Access Compliance Report

Public Rights-of-Way

(Curb Ramps)

Intersection ID: 29180	Main Street: BOXELDER_LN	Cross Street: BIG_LEAF_DR	Location: NE
ADA ID: F9E15F5C27EB	Ramp Type: PerpDiag	Initial Pass/Fail: Fail	Overall Compliance: No
		Severity Score: 10

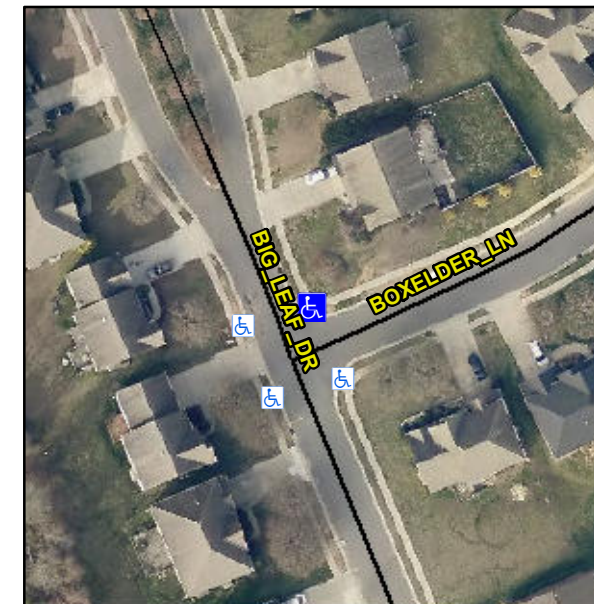
Not Found, R304.5.1, R304.5.3

Compliance	Description	Data	Compliance	Description	Data
N/A	Ramp Length (in)	47.0	Yes	Ramp Slope (%)	6.4
No	Ramp Width (in)	41.5	No	Ramp XSlope (%)	2.3
N/A	Flare Type LT	N/A	N/A	Flare Type RT	N/A
N/A	Flare Slope LT (%)	N/A	N/A	Flare Slope RT (%)	N/A
N/A	Flare Traversable LT?	N/A	N/A	Flare Traversable RT?	N/A
N/A	Landing Length (in)	N/A	N/A	DWS Provided?	N/A
N/A	Landing Width (in)	N/A	N/A	DWS Contrast?	N/A
N/A	Landing Slope (%)	N/A	N/A	DWS Length (in)	N/A
N/A	Landing X Slope (%)	N/A	N/A	DWS Full Width?	N/A
N/A	Landing Curb? (Y/N)	N/A	N/A	DWS Offset (in)	N/A
N/A	Shared Landing?	N/A			
N/A	Gutter Ponding?	N/A	N/A	Gutter Slope (%)	N/A
N/A	Gutter Lip Ht (in)	N/A	N/A	Gutter X Slope (%)	N/A
N/A	Painted X Walk1?	No	N/A	Painted X Walk2?	No
	X Walk 1 Direction	To W		X Walk 2 Direction	To S
N/A	X Walk 1 Width (in)	N/A	N/A	X Walk 2 Width (in)	N/A
	X Walk 1 Slope (%)	5.5		X Walk 2 Slope (%)	0.1
	X Walk 1 X Slope (%)	0.2		X Walk 2 X Slope (%)	1.8

Remove & Replace Curb Ramp With Two New Directional Ramps or Equivalent.
